## **REMARKS**

Attorney Docket No.: AM-9230

10/829,016

Controlling the Properties and Uniformity . . . AM-9230 Page 1 of 4
S. L. Church (650) 473-9700

Fig. 3B

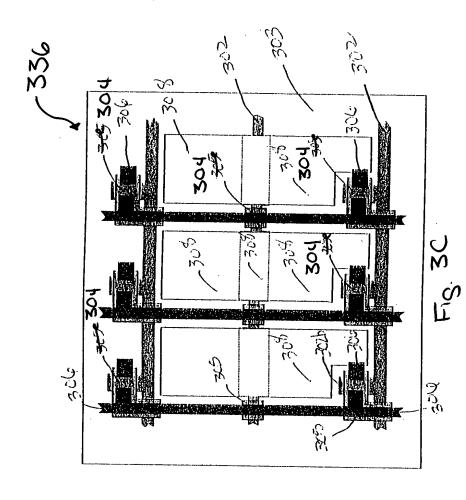
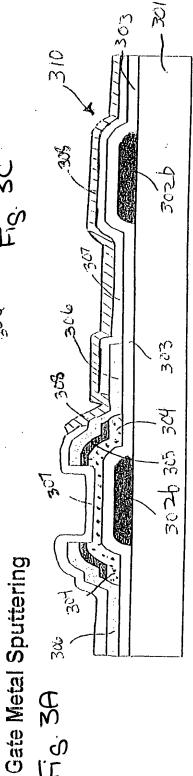
Enclosed is a set of four (4) sheets of informal drawings, which have been labeled "ANNOTATED, MARKED-UP DRAWINGS". Changes are being made only to Sheet 3 of the drawings. Proposed changes to Sheet 3 are shown in red ink. In particular, Sheet 3 shows three distinct figures. These three distinct figures were originally labeled together as Figure 3. On the marked-up, amended Sheet 3 submitted herewith, applicants have re-labeled the three distinct figures as Figures 3A, 3B, and 3C.

Further, applicants have amended Figure 3C to add reference numeral 336, which indicates the schematic top-view of a substrate including several TFT structures of the kind which is illustrated in Figure 3B. The schematic top-view 336 was described at page 17, lines 22 - 23, of applicants' originally filed specification, but reference numeral 336 was inadvertently omitted from the original Figure 3.

Applicants have also amended Figure 3C to correct a labeling error which was present in the original figure. On the original Figure 3C, the elements identified using reference numeral 305 should have been labeled with reference numeral 304. Applicants have therefore amended Figure 3C to change each occurrence of reference numeral 305 to reference numeral 304. This amendment is being made for the purpose of correcting a technical error in the numbering of elements on Figure 3C which is not related to the novel and inventive portion of applicants' claimed invention. According to Paragraph [0063], at page 18, lines 19 - 22, of applicants' originally filed specification: "In the seventh step in the process, "n<sup>+</sup> a-Si Etch-Back", the portion of the "n<sup>+</sup> a-Si layer 305 which was exposed by the patterned dry etch in the sixth step is etched back using techniques known in the art. "n<sup>+</sup> a-Si layer 305 is etched completely through, and is "overetched" into underlying layer 304 of a-Si." Since n+ a-Si layer 305 would have been etched completely through, n+ a-Si layer 305 should not be shown in Figure 3C, and the layer that is actually shown is the underlying a-Si layer

304, which has been exposed upon etchback of the n+ a-Si layer 305. The correction to the drawing

is necessary to correctly depict the structure resulting after n+ a-Si layer etchback.
